**2009 Compliance Recertification Application (2009 CRA)**  
**Compliance Application Review Document (CARD) No. 34**  
**Results of Performance Assessments**

**34.0 BACKGROUND (194.34(a))**

**Figure 34-2. Total Normalized Releases for 100 CCDFs of Replicate R1 of the 2004 CRA PABC (Figure 6-1, PABC Report, Docket A-98-49, Item II-B2-60).**

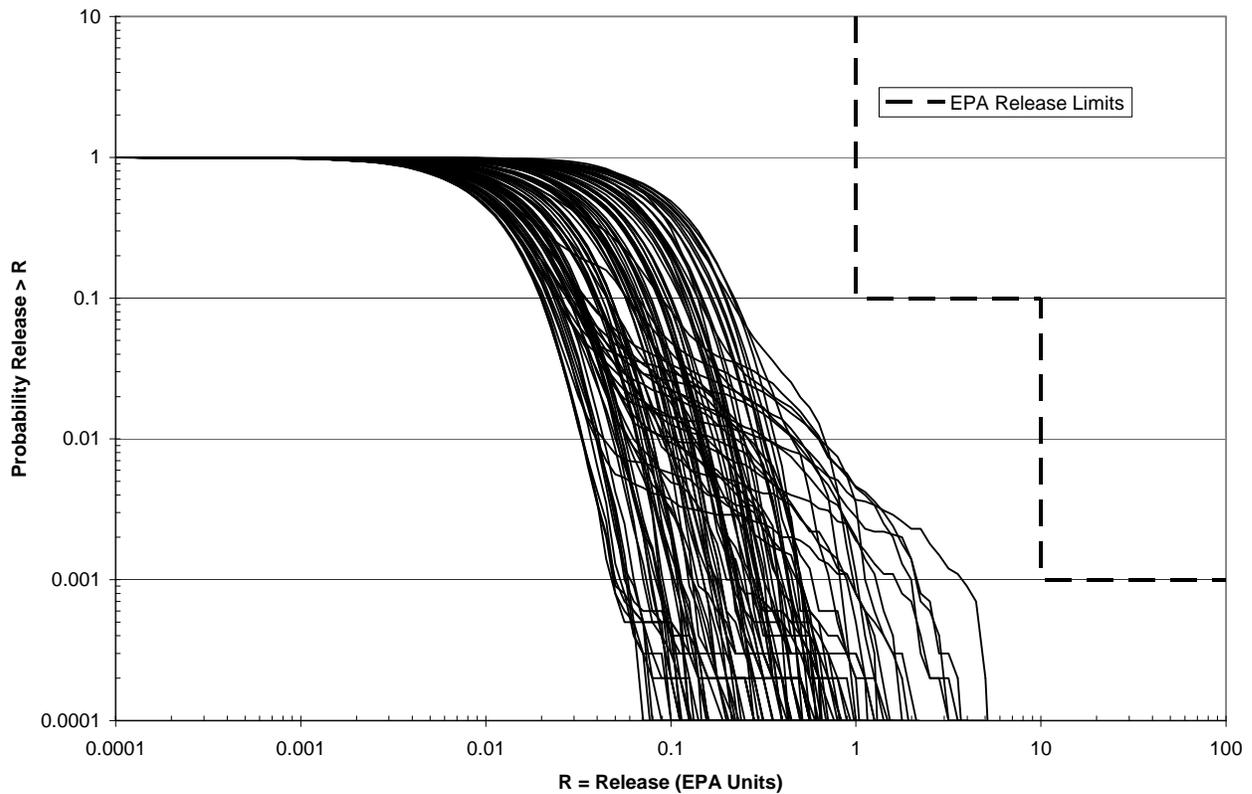
DOE presented and discussed the results of the performance assessment analysis in the 2004 CRA, Chapter 6 and the PABC report, Chapter 6 (Docket A-98-49, Item II-B2-60). Figure 34-2 shows the releases from replicate R1 of the 2004 CRA PABC.

**Figure 34-3. PABC-Confidence Limits on Overall Mean for Total Normalized Releases (Camphouse 2010, Figure 3-33).**

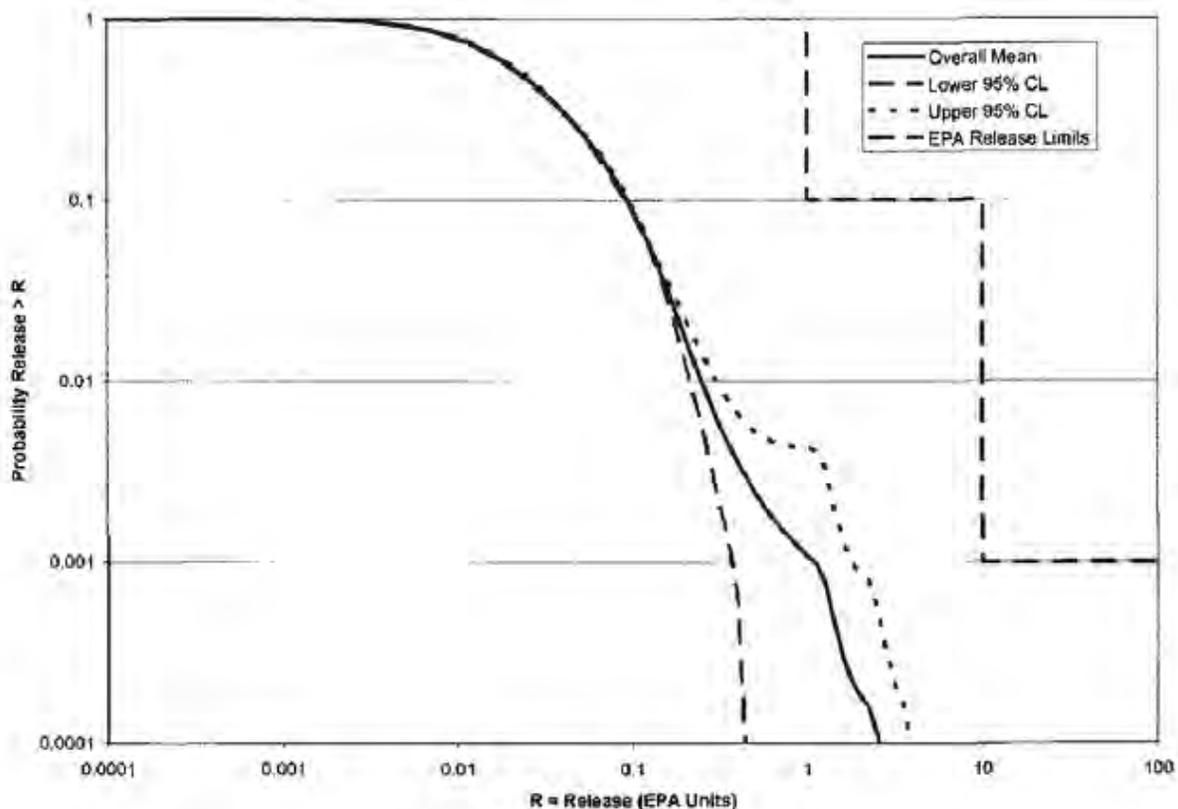
DOE shows the overall mean of the total normalized for the 300 CCDFs, along with the 95% confidence levels about the overall mean for the total normalized releases of the 2009 PABC, in Figure 34-3.

**Figure 34-4. 2009 PABC-Total Normalized Releases in EPA Units Replicates R1, R2, and R3 (Adapted from Clayton et al. 2009, Figure 6-6)**

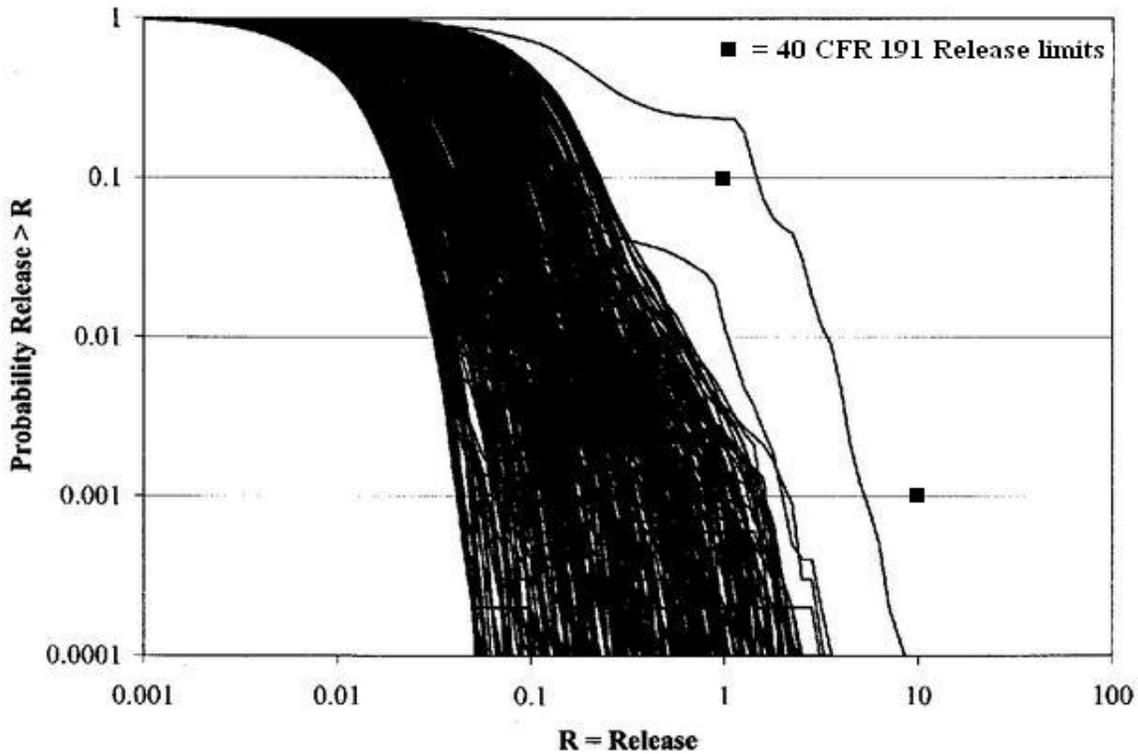
As seen in Figure 34-4, one vector differed considerably from the other 299, and exceeded the compliance release limit at a probability of 0.1. The vector in question is dominated by direct brine releases, or DBR (Clayton et al. 2009). Increases in radionuclide solubilities as a result of inventory changes in the PABC-09 led to greater amounts of mobilized

radionuclides calculated by the PANEL code and available for DBR (Garner 2010). DBR releases may be pessimistic, because the volume of brine used in PANEL to calculate mobilized radionuclides per brine volume does not limit the volume of brine available for DBR in CCDFGF. EPA examined this vector and determined that it does not affect facility compliance, which is determined by the mean of the 300 vectors.
